**RE: Construction Permit Application for a Proposed Utility Waste Landfill, Ameren Missouri
Labadie Energy Center, Franklin County, Missouri, Response to Comment Letter dated May 7,
2013**

Construction Permit Application
Proposed Utility Waste Landfill
Ameren Missouri Labadie Energy Center
Franklin County Missouri

Response to MDNR-SWMP Review Comments

SHEET 8
PROPOSED UTILITY WASTE LANDFILL
CELL 3 GRADING PLAN (TOP OF LINER)

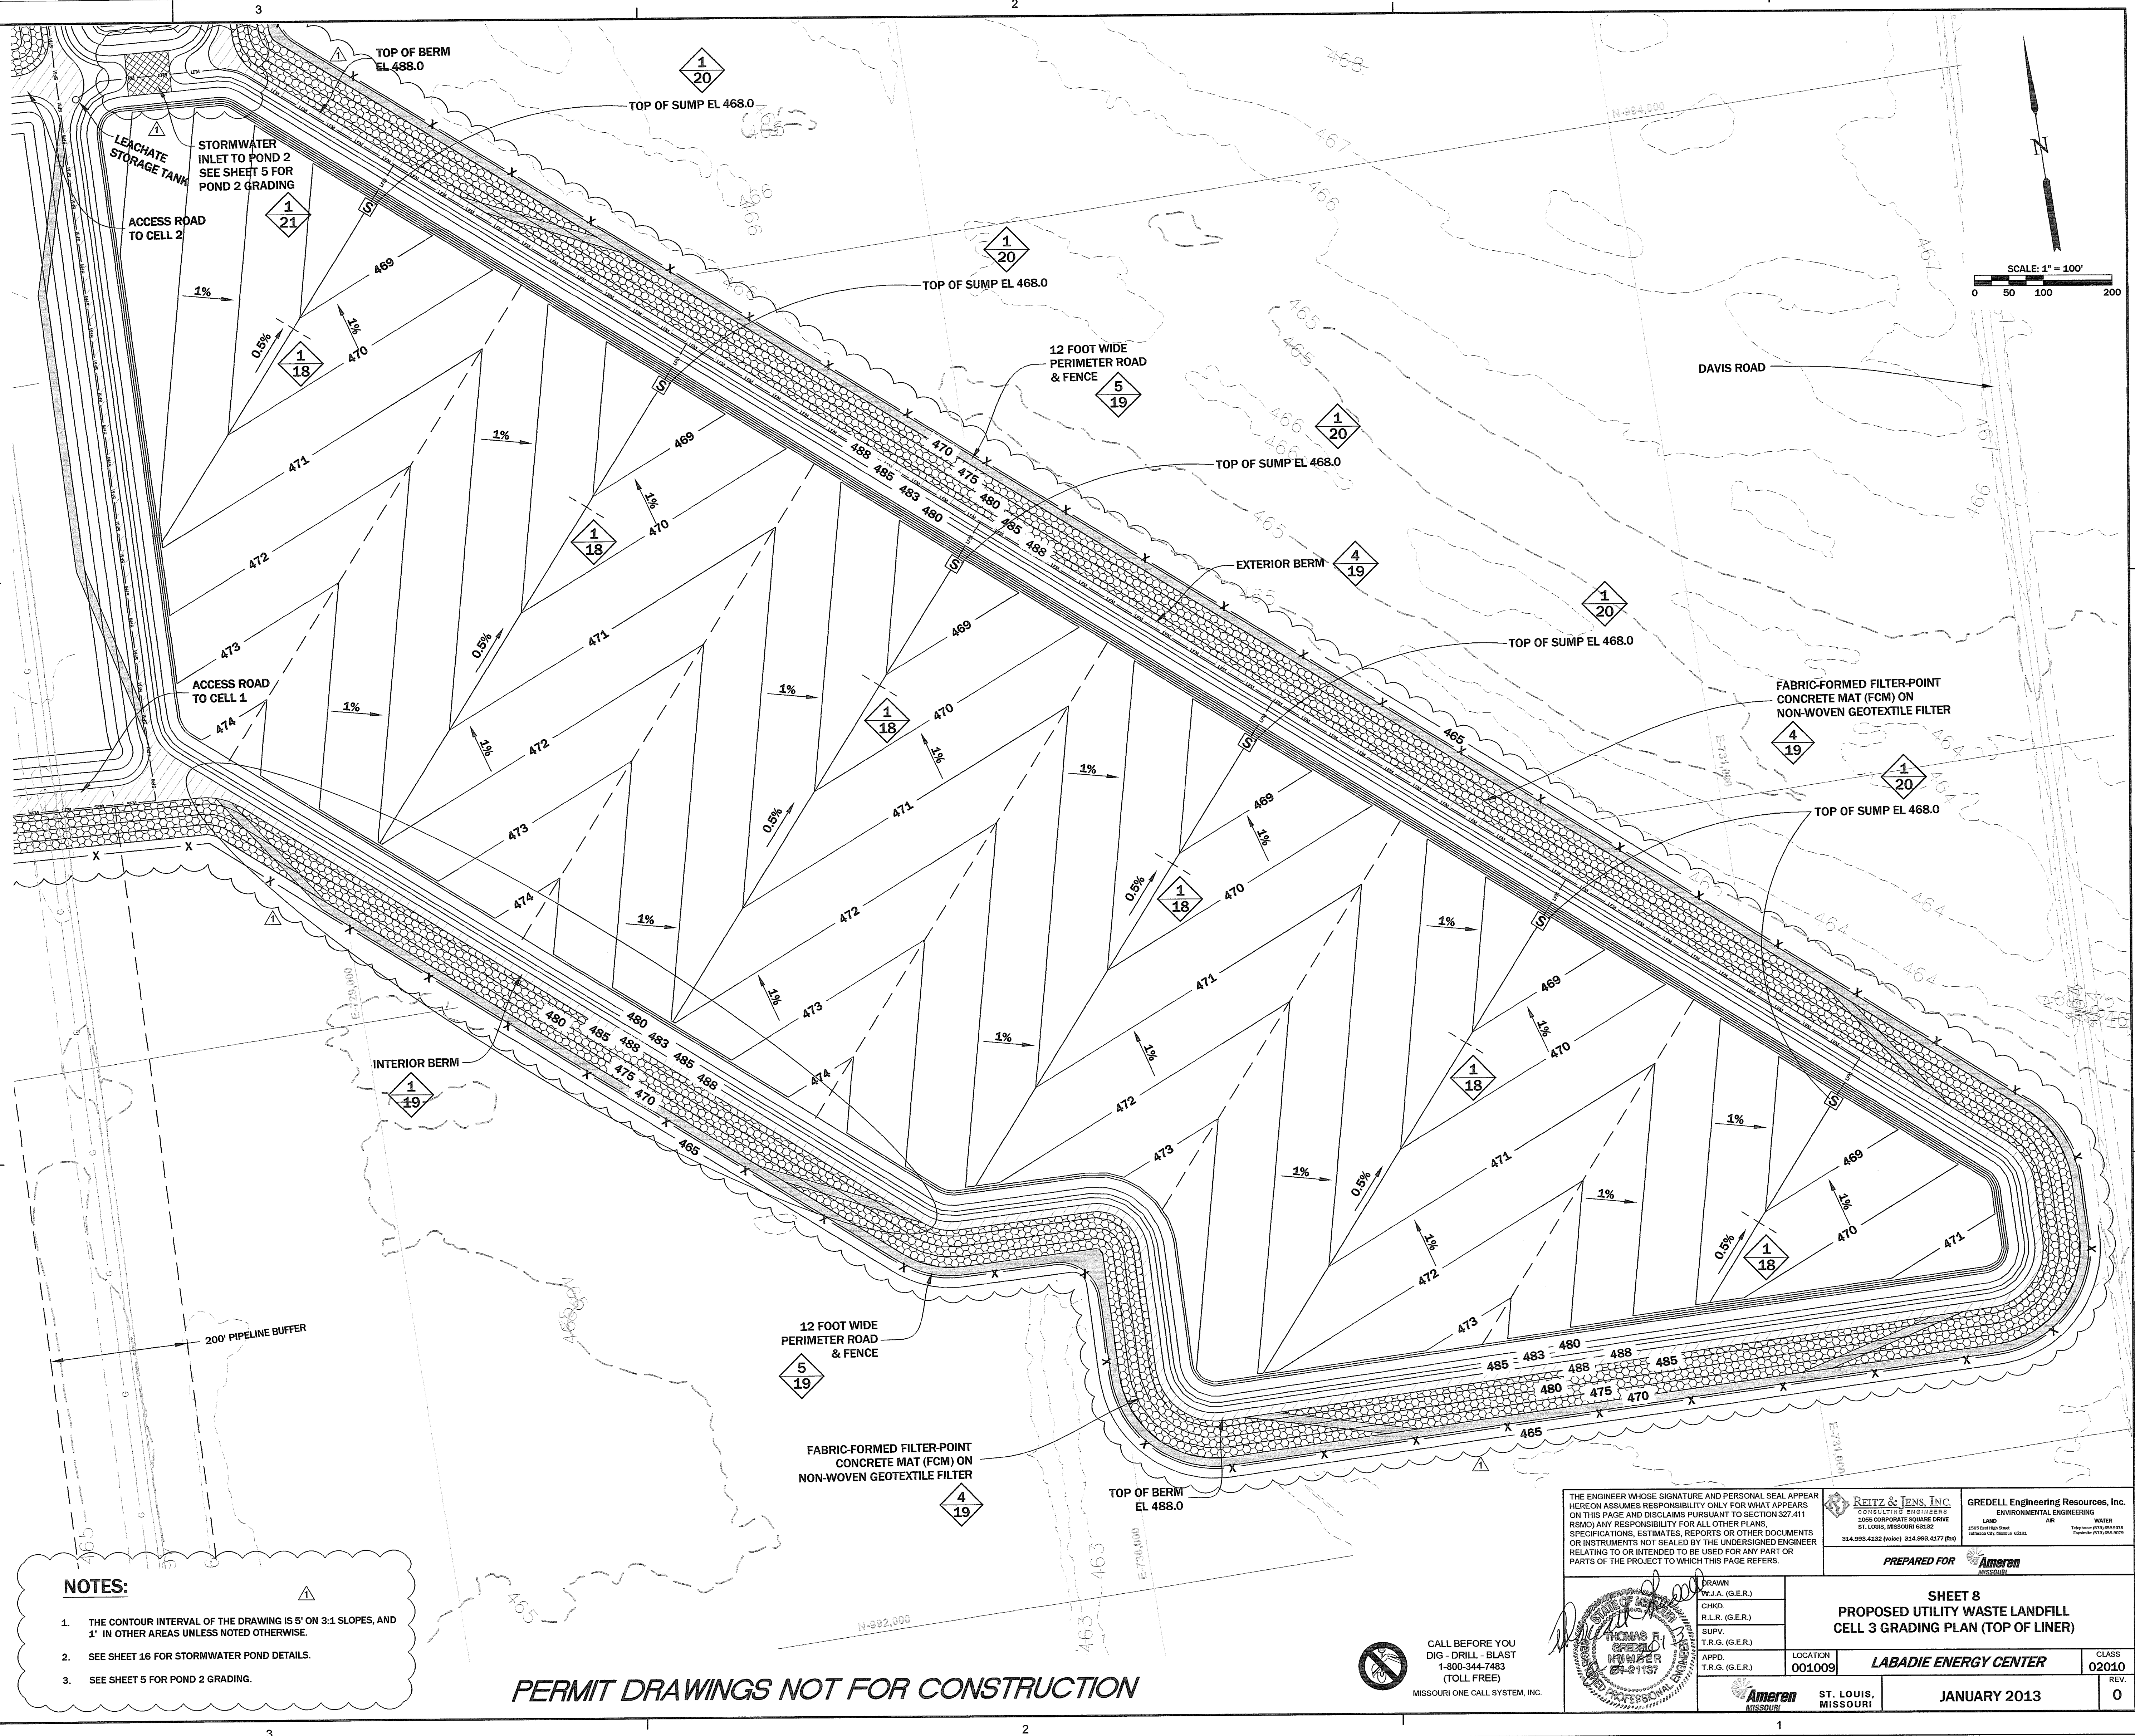
MDNR 11 Show arrows from call-out details to their corresponding features on Sheet 8. **Response:** Sheet 8 has been revised to show arrows from call-out details to their corresponding features on the sheet.

PRINT DIST.		
REVISIONS		
REV.	W.O.	SYM
1		
08/02/13: ADD FABRIC-FORMED TO OUTSIDE TOP OF BERM; ADD HATCH TO STORMWATER INLET; REMOVE NOTE (2.).

SHEET 9
PROPOSED UTILITY WASTE LANDFILL
CELL 4 GRADING PLAN (TOP OF LINER)

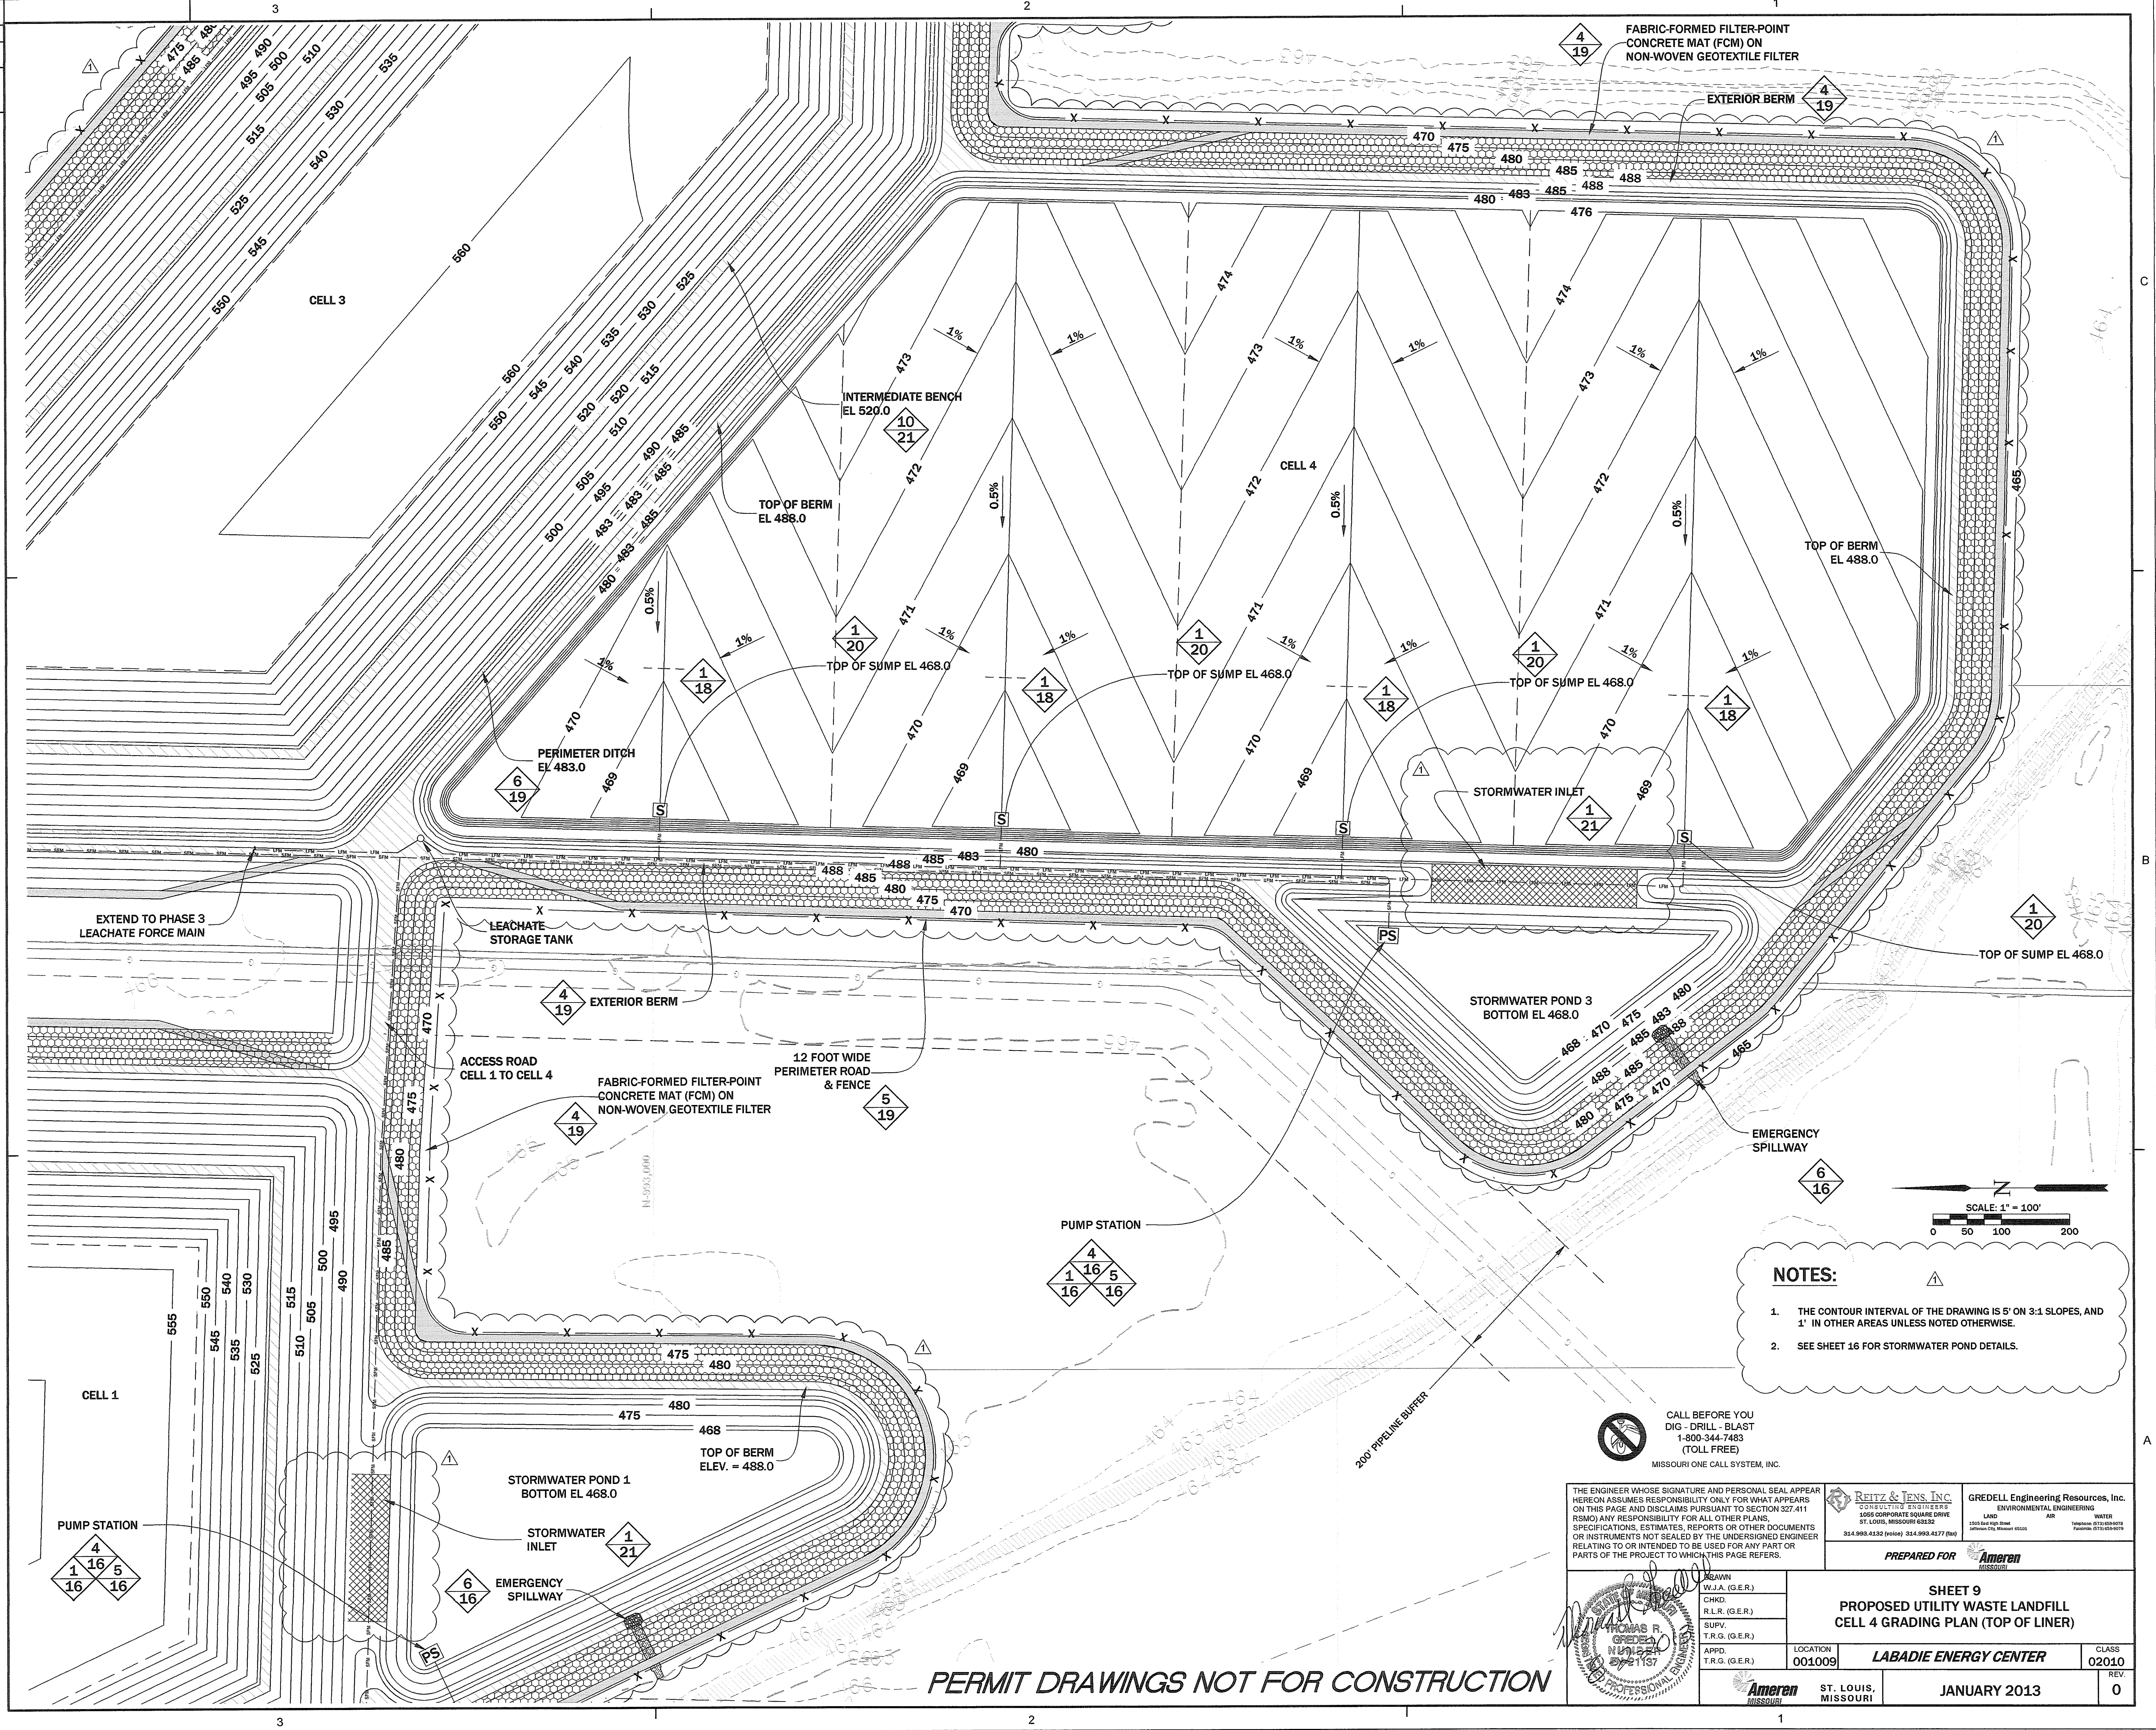
MDNR 28 The exterior slopes of the intermediate berms are not covered with Fabri-Form concrete mat. **Response:** Sheets 6 through 9 and 11 through 14, and Section 3.3.2.1 and 3.3.2.3 have been revised to show the installation of FCM on all exterior berms.

SHEET 10
PROPOSED UTILITY WASTE LANDFILL
OVERALL FINAL GRADING PLAN

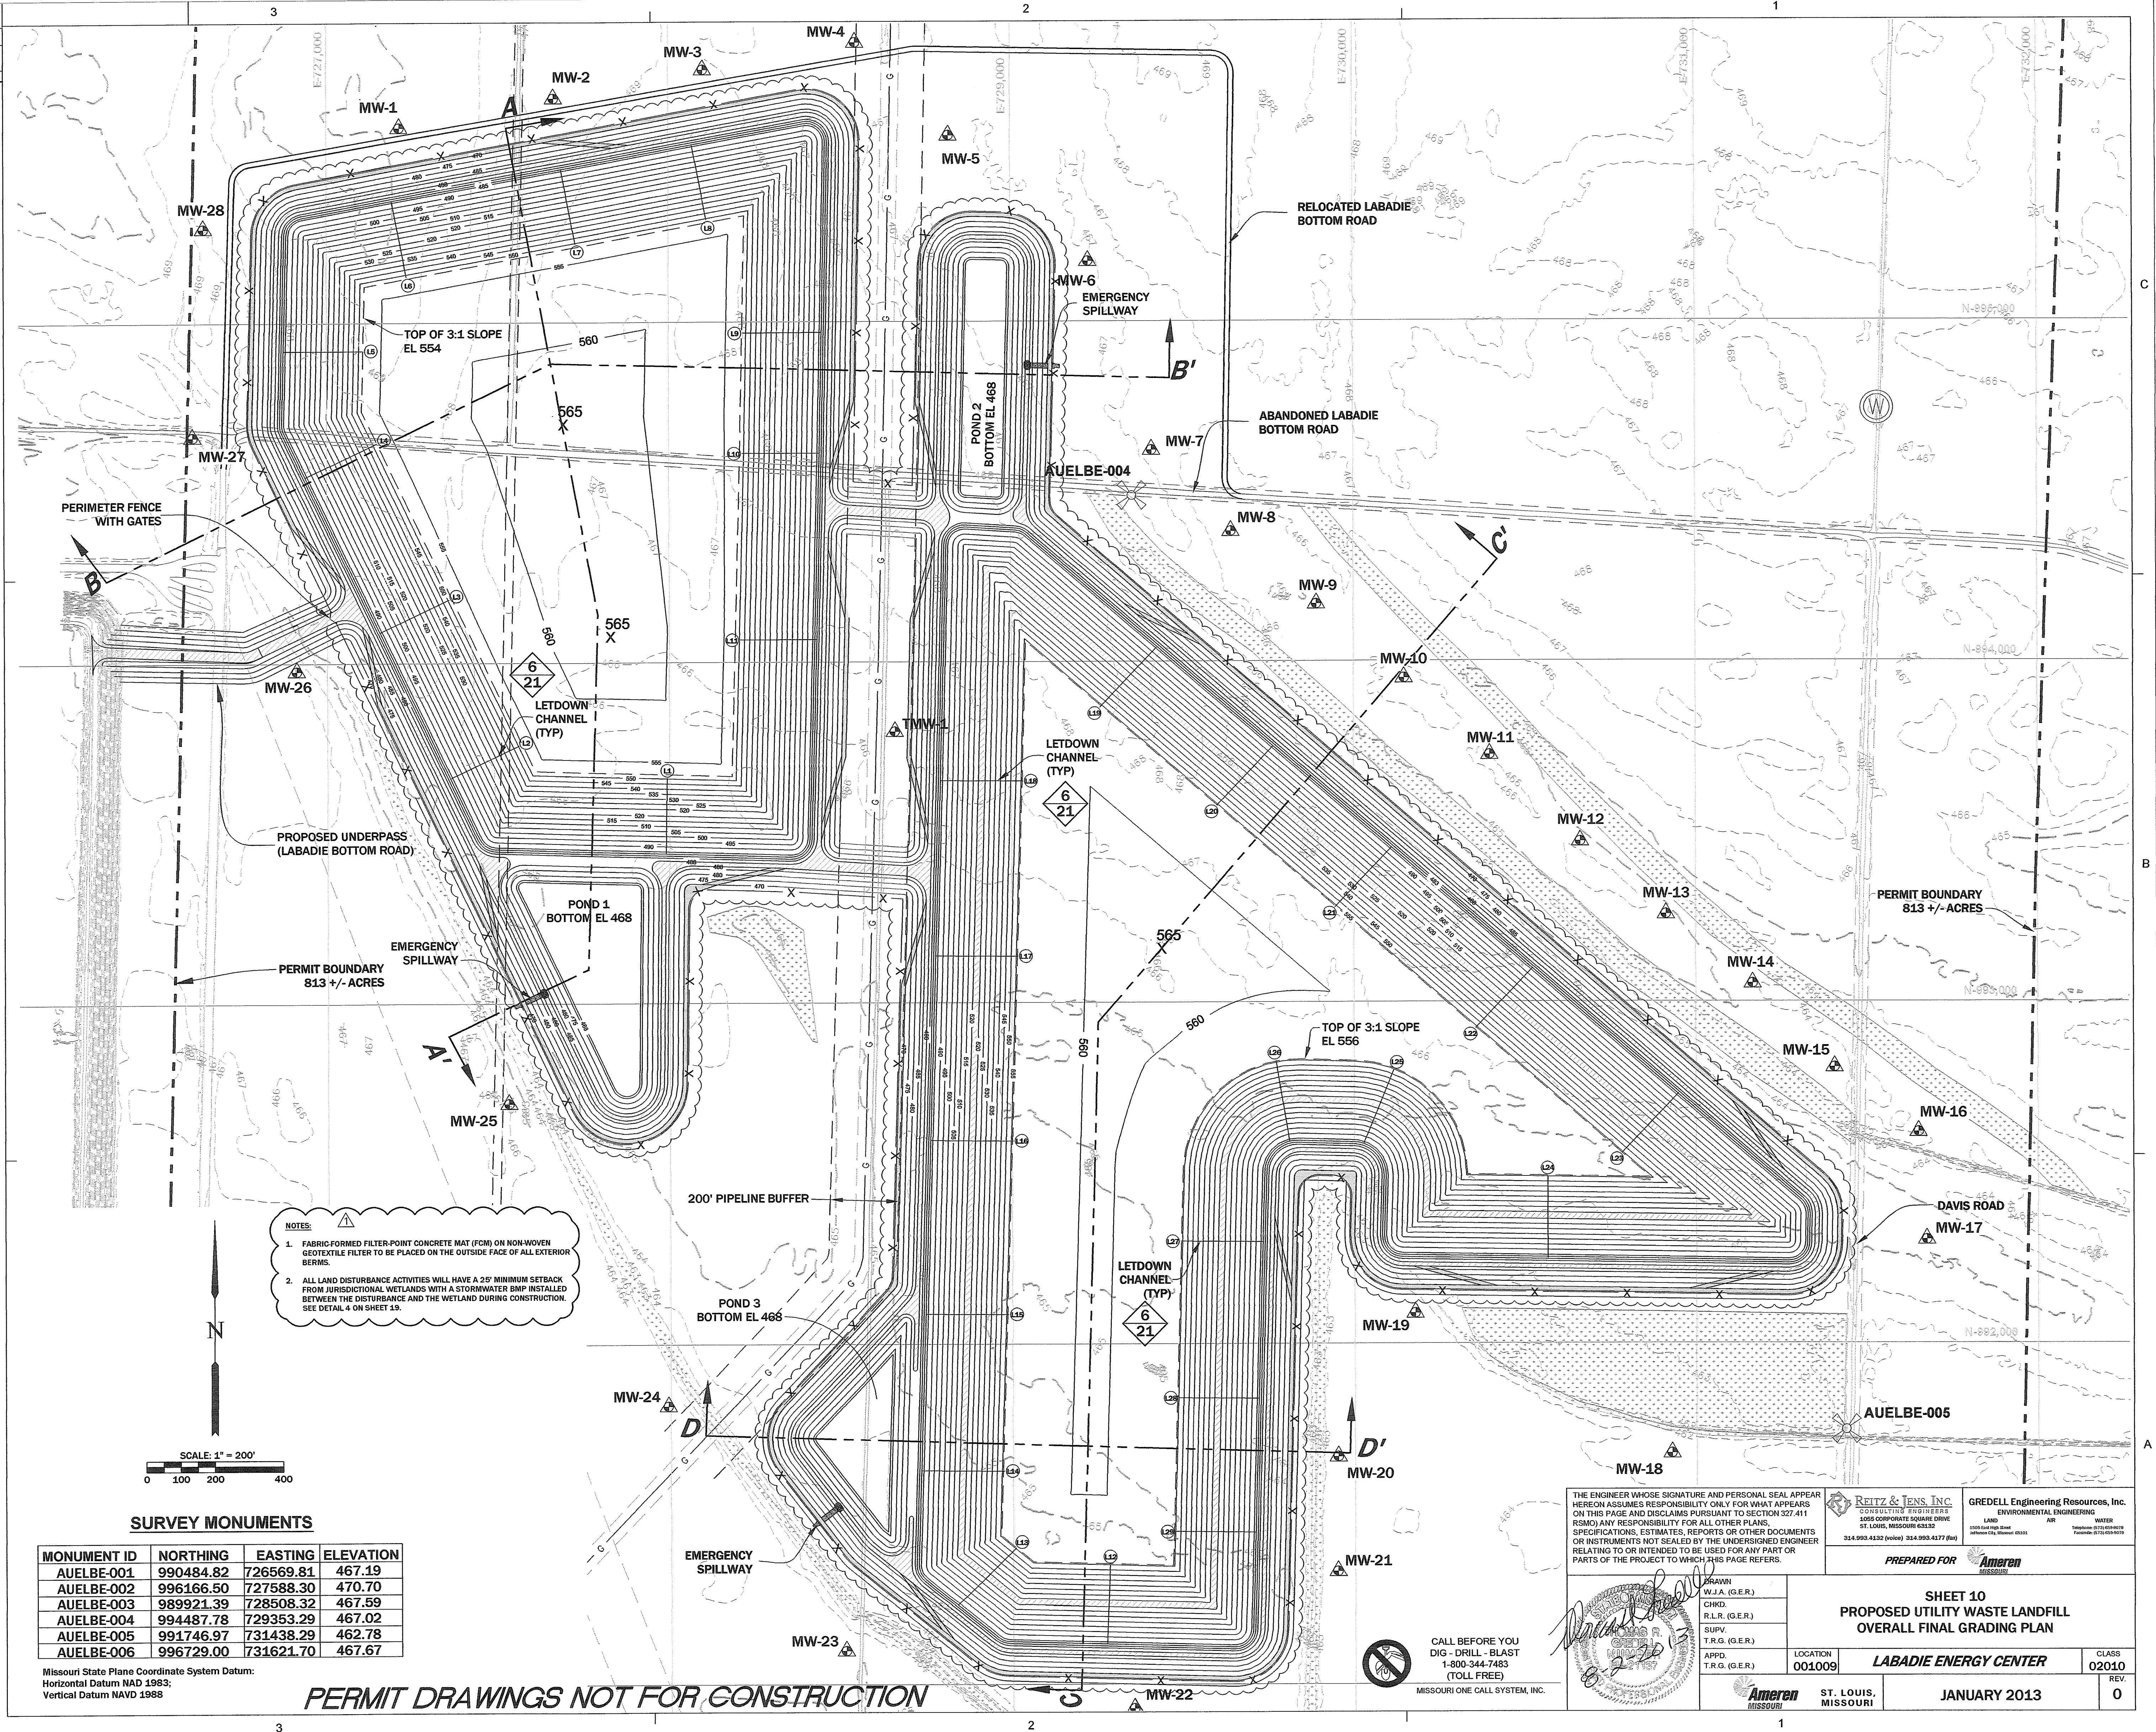
MDNR 9 Please depict the limits of Fabri-Form installation along all berms on all sheets that illustrate the location of the material. **Response:** Sheets 6 through 9 and 11 through 14 have been revised to show the installation of FCM on all exterior berms. Because of the large scale of Sheets 5 and 10 a note was added to each sheet to address this comment.

PRINT	DIST.
REV.	W.O.
1	SYM
08/02/13	ADD NOTES
